CITY OF PROVIDENCE, RHODE ISLAND

Department: Providence Water

**RFP Title: WESTERN JOHNSTON HIGH SERVICE EXPANSION (Water Tank) –
CONTRACT 1 (EXP. 12/31/24)**

Addendum #: 2

SITE PLAN
 DRAWING NO.: **C3.0**
 SHEET NO. 5 OF 8

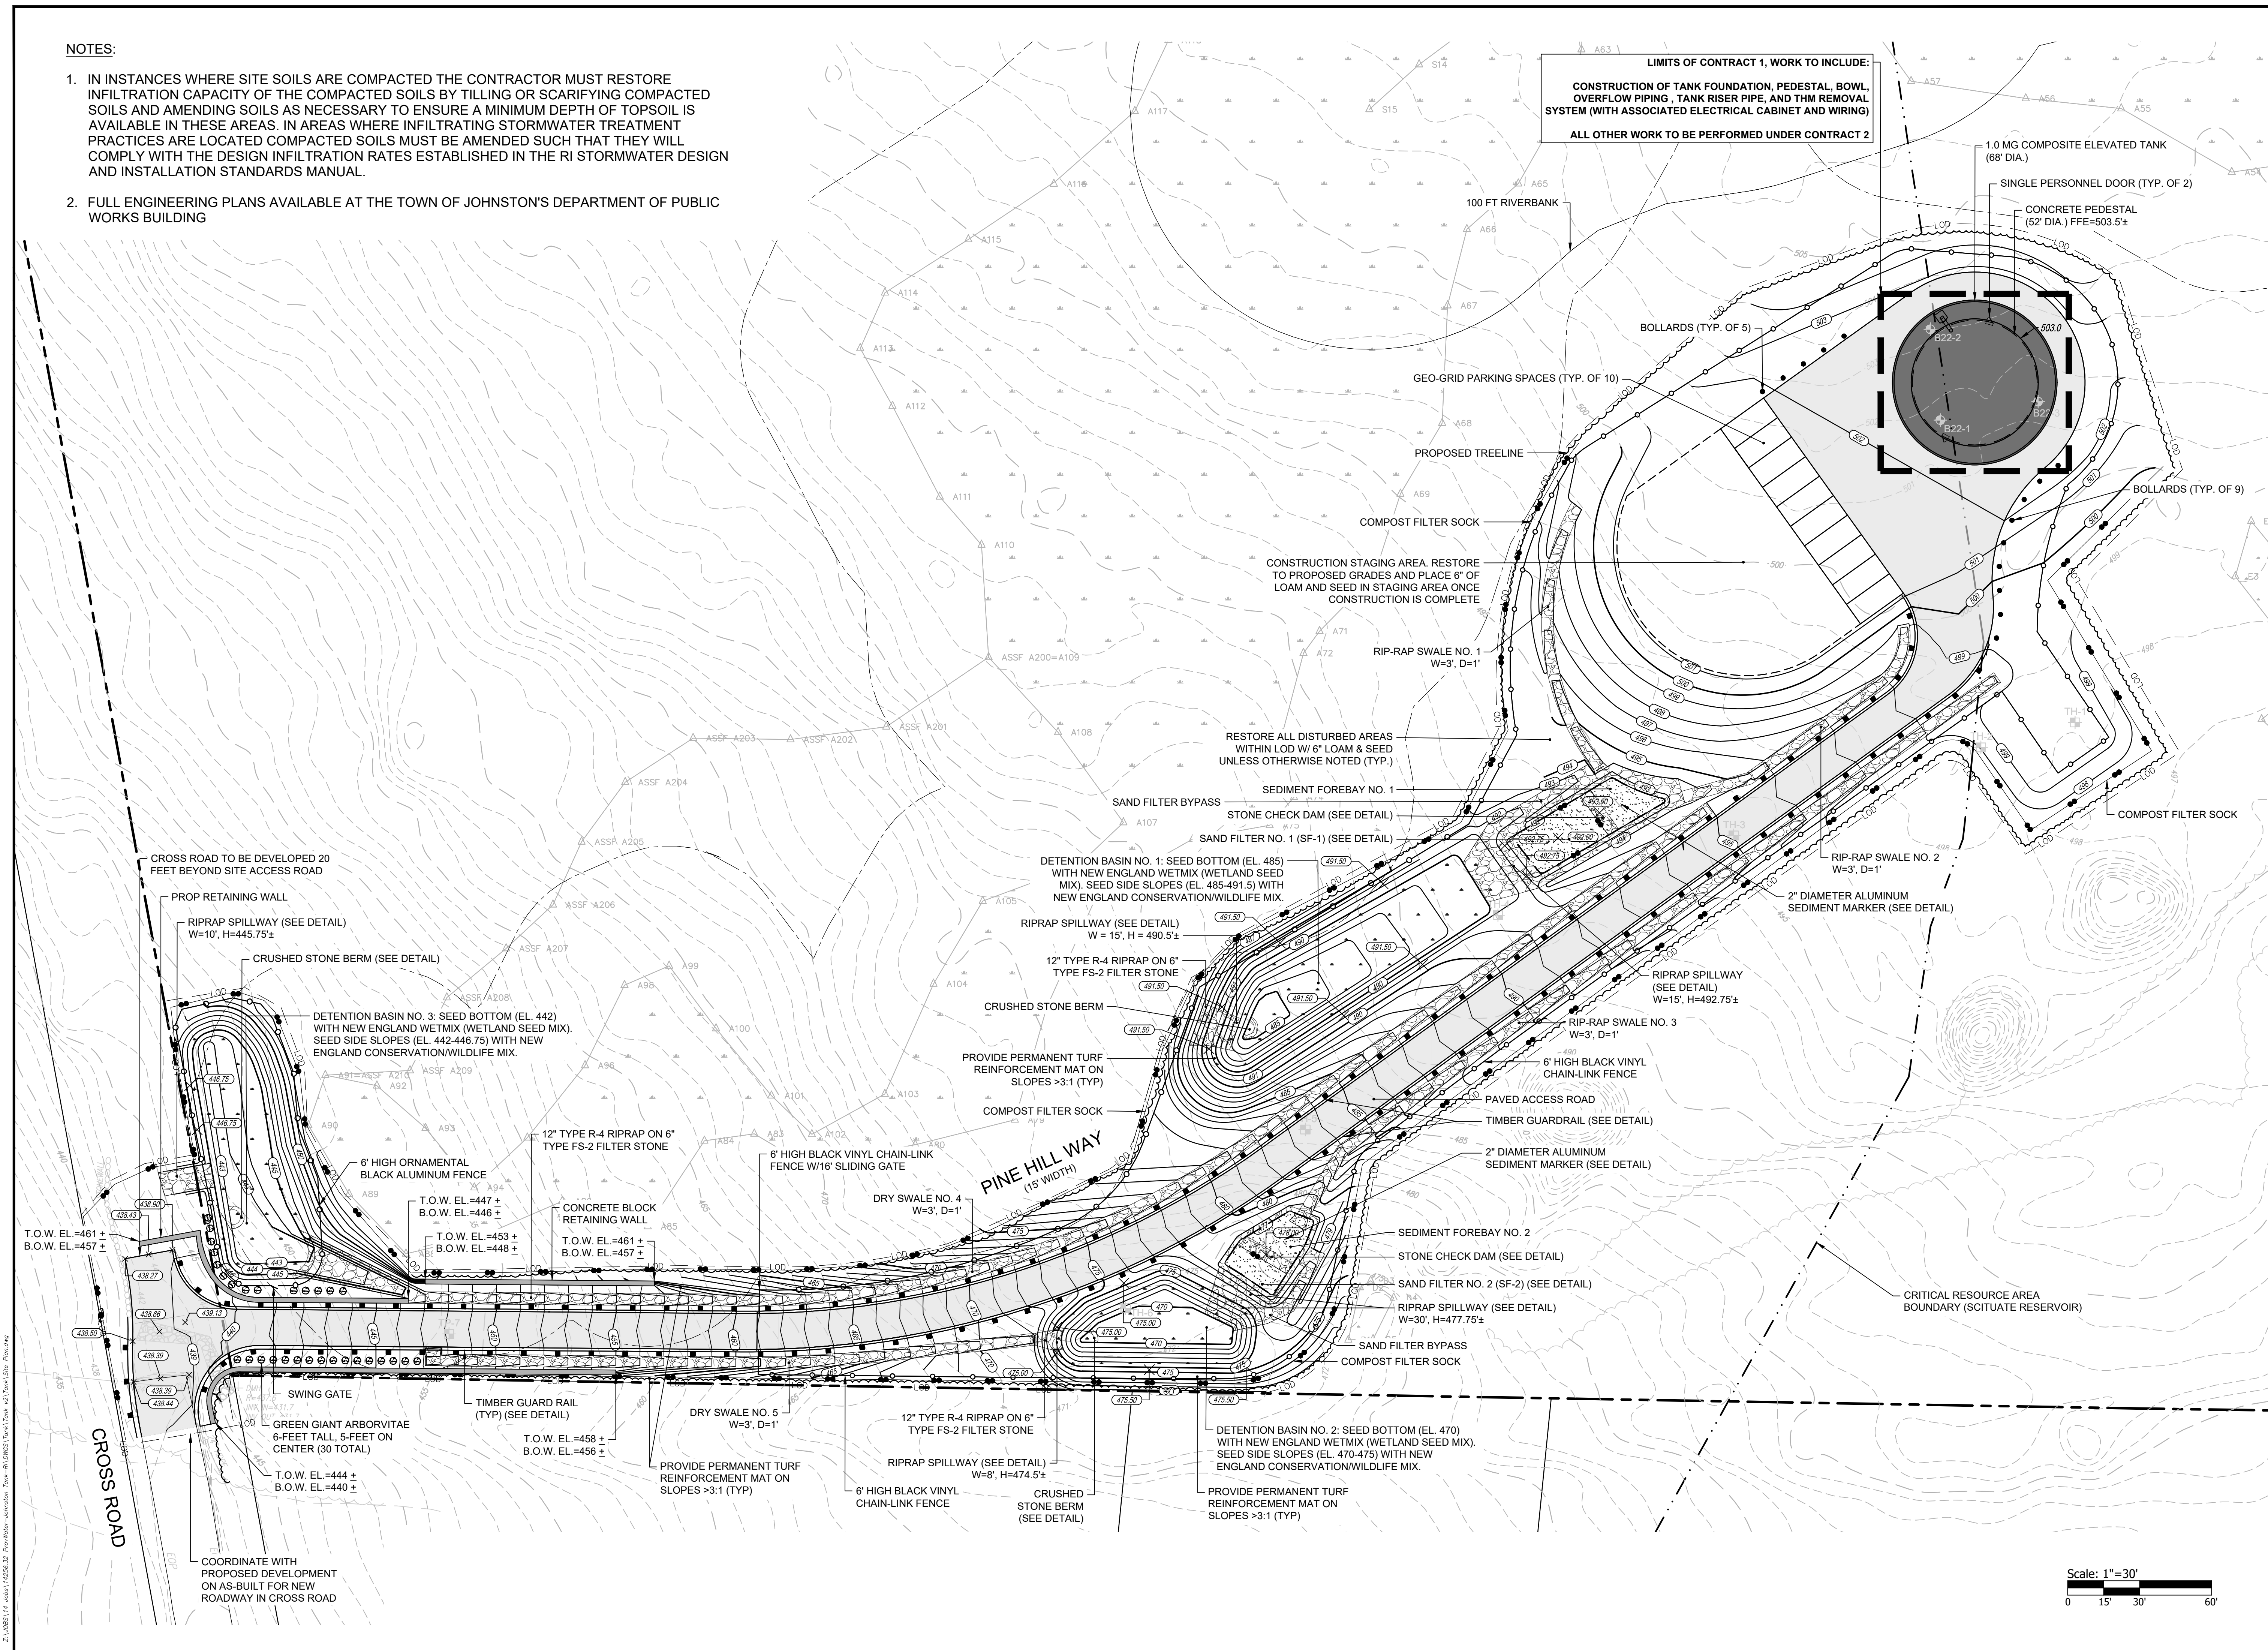
- **SHEET 3.0 – SITE PLAN** (Contract 2 related modifications are italicized)

Replace sheet C3.0 in its entirety with Revised Sheet C4.0 – Site Plan (Addendum No. 3). The revised sheet is attached to this addendum.

1. Remove “TP-1” from sheet;
2. *Replace “TP-2” with “TH-7”;*
3. *For callouts concerning the 6’ ornamental fence, replace with “6’ high black vinyl chain-link fence”;*
4. *Remove callout “Contractor to remove boulders” from sheet; and*
5. *Add top of wall (TOW) and bottom of wall (BOW) elevations to retaining walls.*

PLAN
SCALE: 3/16" = 1'

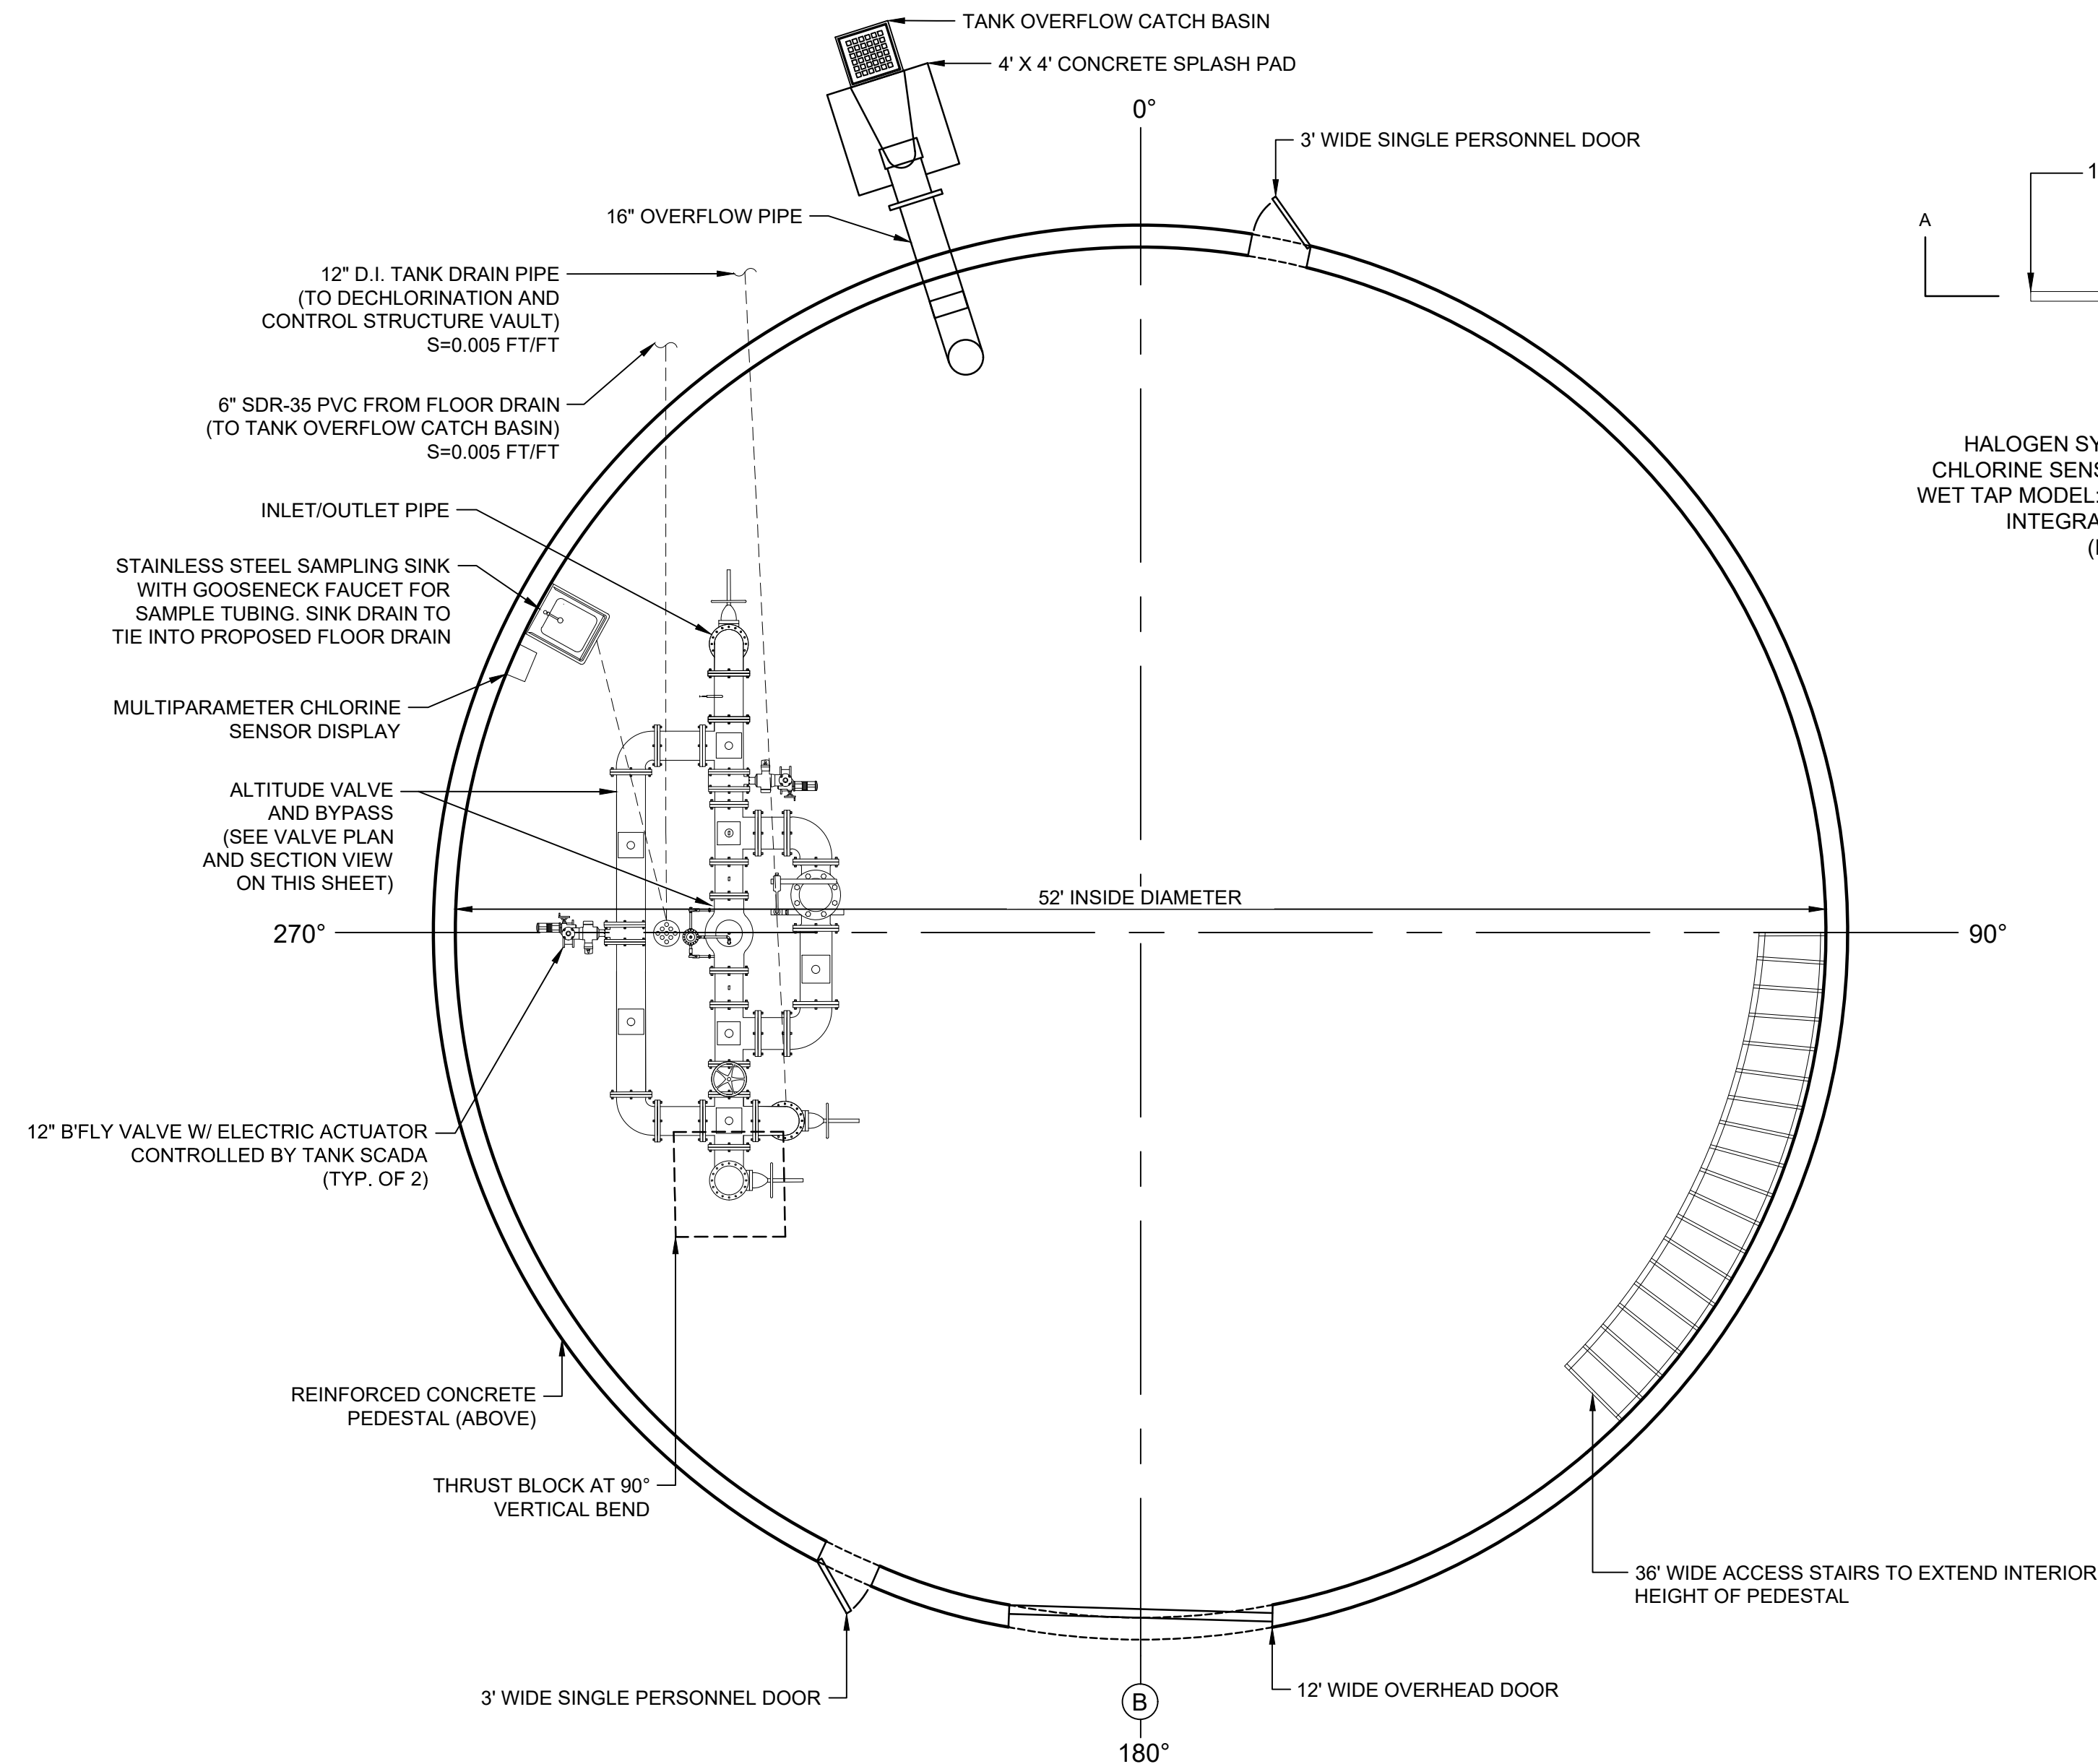
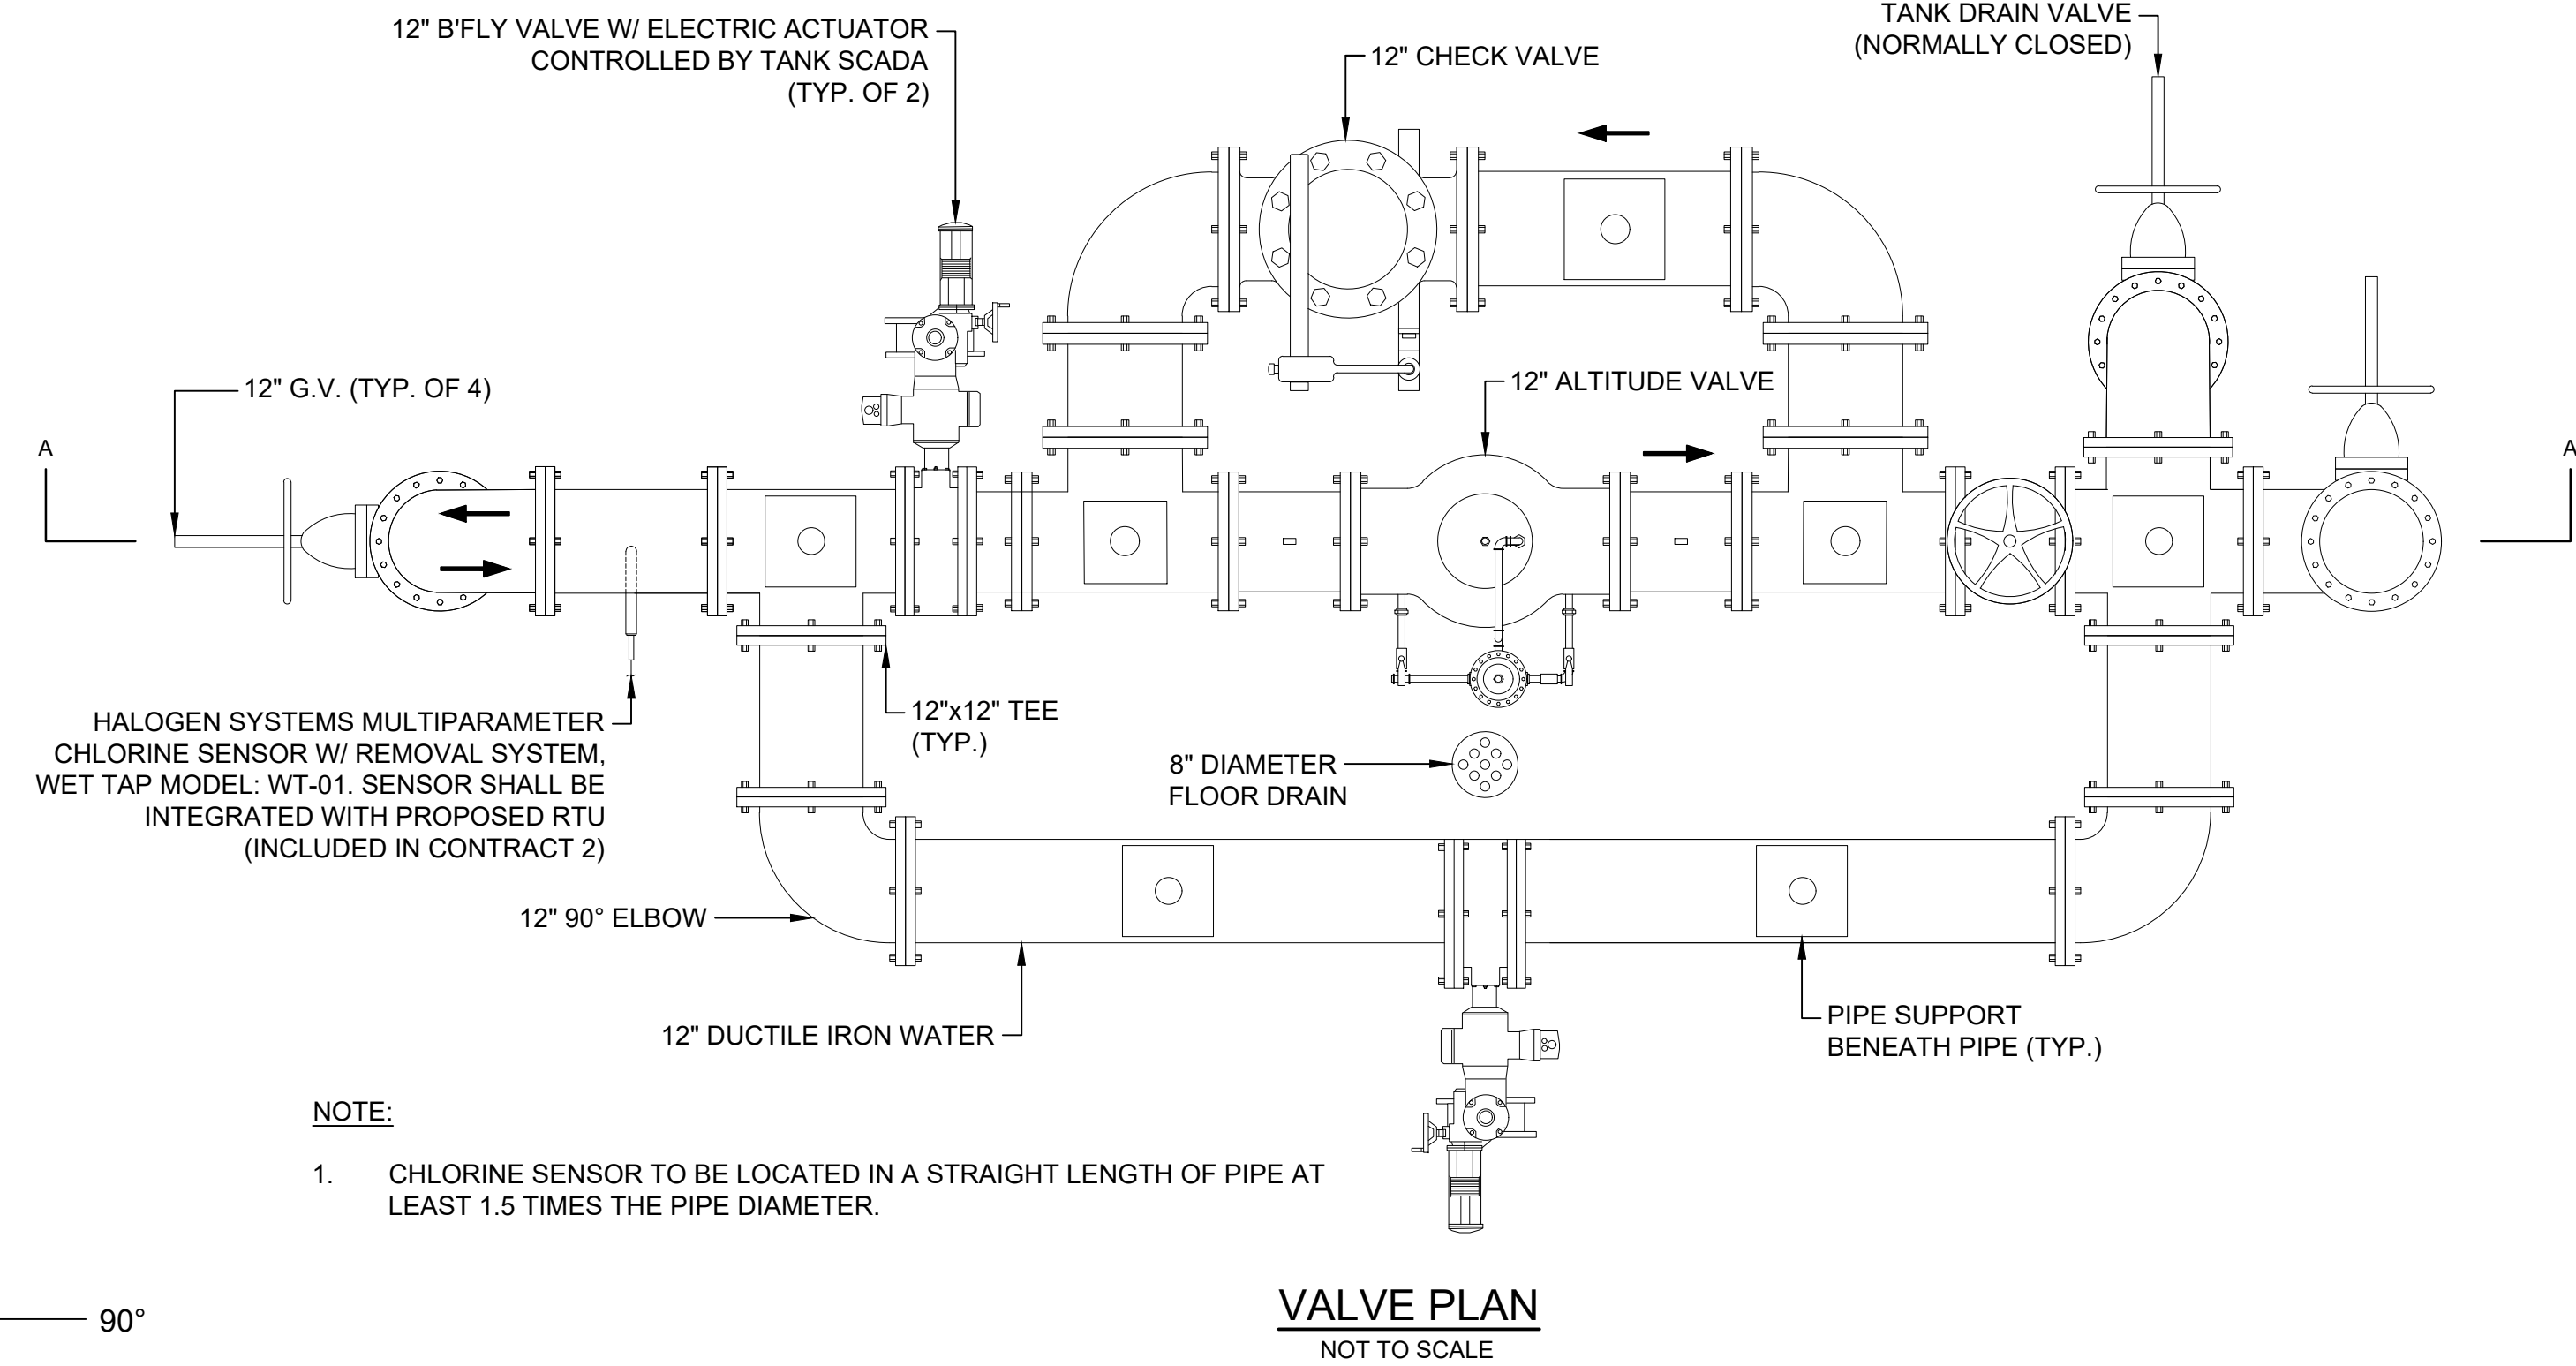
- **SHEET C5.1 – DETAILS 1** (Contract 2 related modifications are italicized)

Replace sheet C5.1 in its entirety with Revised Sheet C5.1 – Details 1 (Addendum No. 3). The revised sheet is attached to this addendum.

1. Replace overhead door callout with “12’ wide overhead door”;
2. *Remove pH and Chlorine Analyzers;*
3. *Remove Chlorine Analyzer Waste Drain Detail;*
4. *Remove “P” Trap Detail;*
5. *Remove Process Flow Schematic – pH & Chlorine Analyzer Detail; and*
6. *Add multiparameter chlorine sensor along interior piping with the following callout “Halogen Systems Multiparameter Chlorine Sensor w/ removal system, wet tap model: WT-01. Sensor shall be integrated with proposed RTU (included in Contract 2)”;* and
7. *Add note to Valve Plan: “Chlorine sensor to be located in a straight length of pipe at least 1.5 times the pipe diameter”.*

- 4. Overhead & Personnel Doors – The elevation view on Drawing C4.0 references a 12’ wide overhead door. The plan view on Drawing C5.1 references a 10’ wide overhead door and two (2) personnel doors. Please confirm overhead door size and quantity of personnel doors (typically 1 at base and 1 at top).**

The overhead door shall have a width of 12-feet. The interior pedestal will have three (3) personnel doors – two (2) at base and one (1) at top.

1. CHLORINE SENSOR TO BE LOCATED IN A STRAIGHT LENGTH OF PIPE AT LEAST 1.5 TIMES THE PIPE DIAMETER.
